Crystal River Nuclear Plant
Docket No. 50-302
Operating License No. DPR-72

December 3, 2010
3F1210-07

Subject: Crystal River Unit 3 – Response to Request for Additional Information Regarding 10 CFR 50.46 Notification of Change in Peak Cladding Temperature for Small Break Loss Of Coolant Accident Analysis (TAC No. ME4944)

RESPONSE TO REQUEST FOR ADDITIONAL INFORMATION

Figure 1. SBLOCA 9.5-ft Axial Shape with Characteristic BOC and MOC Limiting Axial Shapes

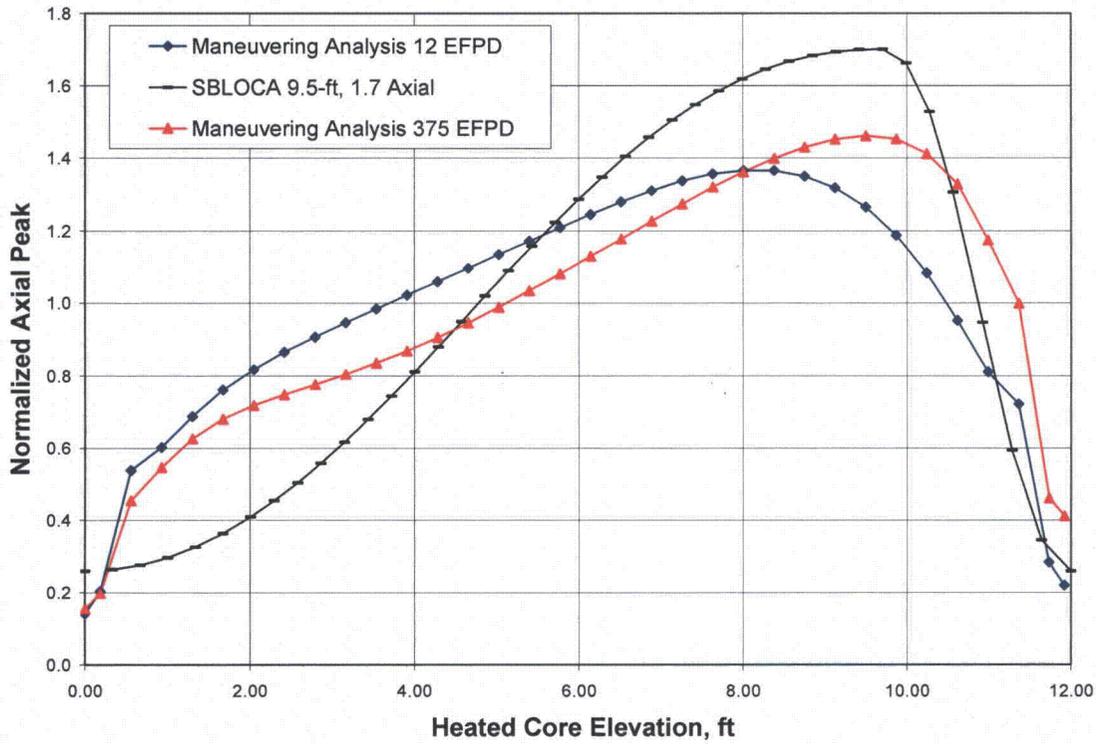
Review of the representative core power distributions showed that at BOC the top-skewed axial power profile was bounded by the 9.5-ft axial power shape used in the current SBLOCA analyses. Figure 1 provides this comparison. Also, shown in this figure is a MOC axial power shape at 375 effective full power days (EFPD). The peak locations coincide with the MOC case

Figure 2. SBLOCA 9.5-ft Axial Shape with Characteristic EOC Limiting Axial Shapes

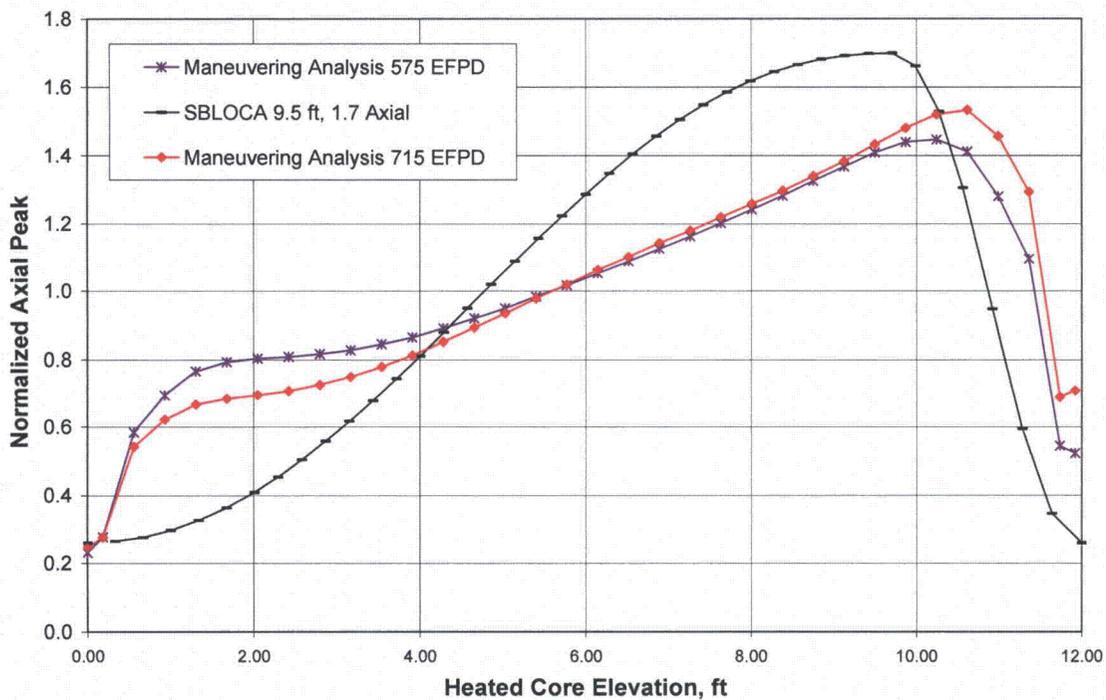
and the axial shape is also reasonably bounded by the SBLOCA analysis shape. With increasing core burnup, the margins between the maneuvering analysis peaks and the LOCA normalized axial peak increases, but the axial peak elevations are no longer bounded by the shape used in the previous SBLOCA analyses. In Figure 2 the 575 EFPD burnup axial peak is just barely bounded by the 9.5-ft SBLOCA axial shape, but the 715 EFPD elevation of the axial peak is not bounded.

Figure 3. SBLOCA 9.5-ft Axial Shape with Characteristic Limiting Axial Shapes for all Times in Cycle

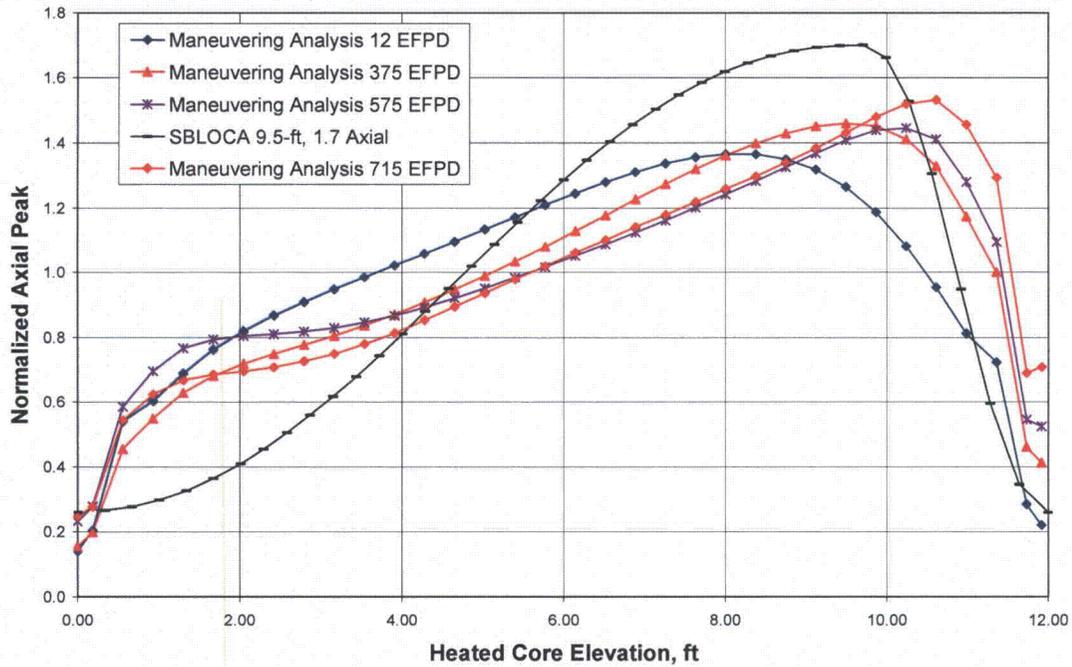
Figure 3 combines all the power shapes and shows the increasing elevation of the axial peaks with increased burnup. In order to bound the EOC peak elevations, a new SBLOCA normalized axial power shape was created. The 11-ft axial peak selected for use in new SBLOCA analyses is shown in Figure 4 along with the BOC and EOC shapes. The 11-ft shape covers all times in cycle; however, it is very conservative for the BOC case. It is also noted that the EOC peaks were generated by core power distribution cases that typically produce imbalances larger than those allowed by Technical Specifications for plant operation. If the Technical Specification allowable axial power imbalance limits were used, the elevations of the axial peaks would not change but the magnitude of the axial peak would decrease. It was concluded that unless cycle-specific SBLOCA analyses were undertaken, the 1.7 normalized axial shape peaked at the 11-ft elevation should be used to bound all current and future cycles. The magnitude of the peak is bounding for EOC peaks and its use in the SBLOCA analyses with maximum allowed LHR limits (total peaks) will not impact the plant LOCA limits specified in the Core Operating Limits Report (COLR) or add considerable efforts to the cycle-specific maneuvering analyses. In essence, the selection described imposes additional conservatism on the SBLOCA calculated PCTs by imposing higher axial peaks to avert LHR limit reductions and minimize the burden on the future cycle-specific core peaking design checks.

Figure 5. Quasi-SS SBLOCA Steam and Clad Temperatures with a 10 ft Mixture Level at 20 Minutes

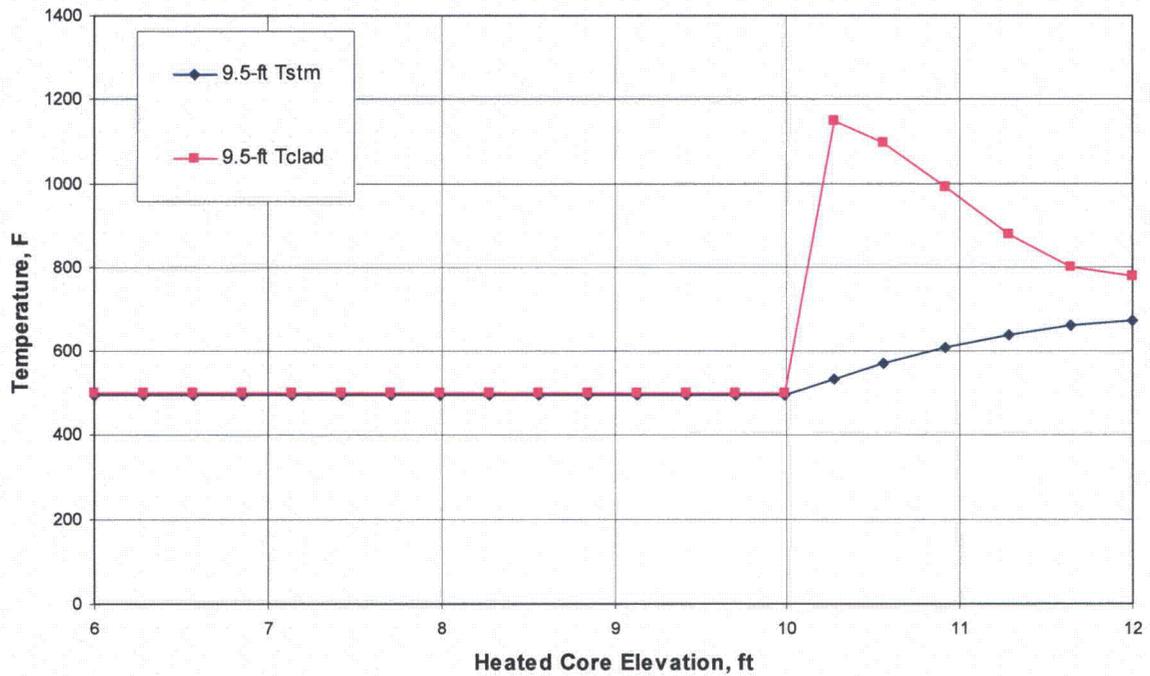
The core power at the time of the quasi-steady state conditions determines the temperature difference between the cladding and steam. If the decay heat is lower, the PCT is lower. The core power decreases above the original 9.5-ft axial peak in the core; therefore, the cladding temperature decreases with increasing elevation. Figure 5 shows a representative steam and cladding temperature approximation when the 9.5-ft axial peak is used with a 10-ft mixture level. In this case the peak power location is below the mixture level and the PCT is predicted at approximately 10.3 ft with a steam temperature that is closer to the saturation value. The PCT occurs at a location in the rod with a power level that is considerably lower than the total peak. Since the power peak is lower, the PCT is lower.

Figure 6. Quasi-SS SBLOCA Steam and Clad Temperatures with a 10 ft Mixture Level at 20 Minutes

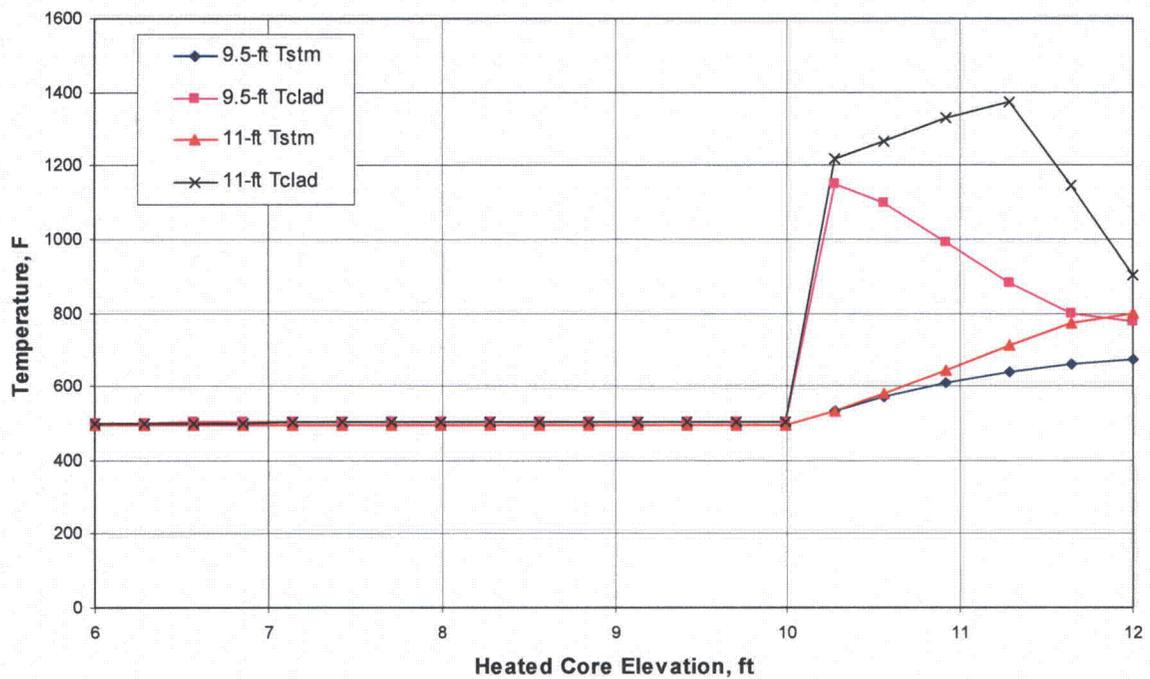
When the 11-ft axial peak is used for a similar case, the PCT occurs near the peak power location. Figure 6 adds the cladding and steam temperatures for the 11-ft axial peak along with the 9.5-ft temperatures from Figure 5. The two key differences are that the steam temperature and power generation are higher. Consequently, the steam temperature plus the temperature difference between the cladding and steam, results in the maximum PCT value at the 11.3-ft core elevation. This resultant PCT is approximately 225 F higher than the 9.5-ft axial PCT based on the quasi-steady state prediction.

Figure 7. Plant-Specific Mark-B-HTP SBLOCA PCT Comparison versus Break Size

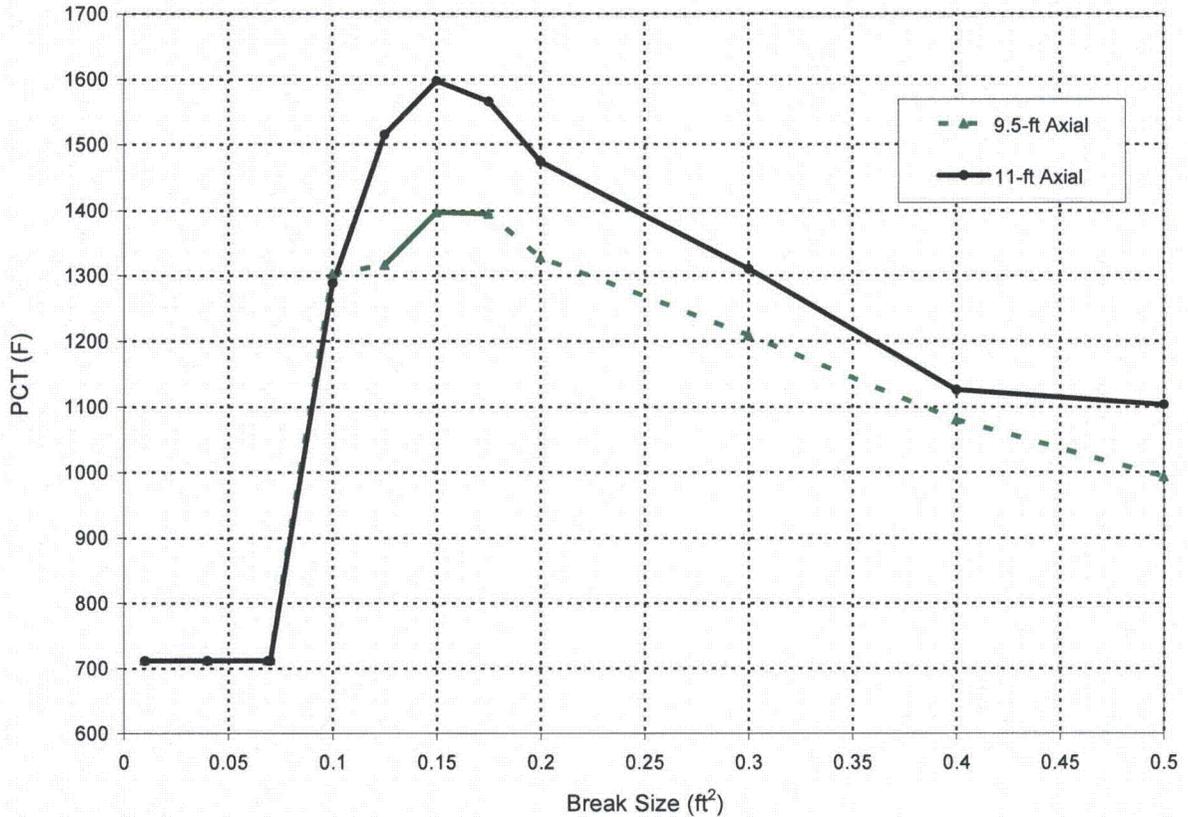
Several cursory SBLOCA RELAP5 cases were performed with the axial power shape changed from 9.5-ft to 11-ft peak elevation. These EM-method based cases also confirmed that the 225 F increase was a bounding value for the PCT cases. Since the time when the SBLOCA CR was written, one revised SBLOCA spectrum has been completed and documented for one 177-FA lowered loop plant. These new SBLOCA analyses used the 11-ft axial power shape and two other slight input changes to the actinide decay heat contribution and the steam generator tube plugging (SGTP) fractions. Both of these changes do not significantly change the PCTs, but they would both tend to increase the PCTs slightly. Figure 7 shows the PCT differences for the two cold leg pump discharge (CLPD) spectrums.

The PCT differences observed for the spectrum of CLPD breaks in Figure 7 shows that the 225 F value assigned to the PCT is reasonable, yet bounding. The smaller break sizes for this spectrum did not have core uncovering so there was no PCT increase. The intermediate to larger SBLOCAs had PCT increases less than the 225 F value assigned generically to all plants prior to completion on any formal reanalyses. The larger SBLOCA sizes evolve rapidly and do not have time to achieve the quasi-steady state conditions used to develop the 225 F estimated increase. For these reasons, the PCT differences for larger SBLOCAs will be smaller than the 225 F value assigned to the limiting PCT case. The smaller break sizes have more potential to evolve to the quasi-steady-state conditions that were assumed. These break sizes, however, achieve those conditions at a later time, with a lower decay heat level and generally higher mixture level. When the decay heat is lower, the cladding to steam temperature difference is less and the PCT increase will be less than the 225 F assigned to all breaks with core uncovering at an earlier time period in the CR evaluation. The overall conclusion is that the PCT increase for all plants should be less than the 225 F estimate created to provide a reasonable bounding value for the limiting SBLOCA.

A generic PCT increase was initially evaluated with a first principles approximation, and its validity initially supported with cursory analyses. The validity has been confirmed by recently completed RELAP5/MOD2-B&W EM analyses for the spectrum of break sizes as shown in Figure 7 for at least one plant. Analyses are in progress for other plants. The generic PCT increase of 225 F was applied to all the 177-FA plants as an immediate response to the condition report. The 225 F PCT increase is a generic, conservative estimate that can be used until plant-specific analyses for this EOC axial peaking error are completed.
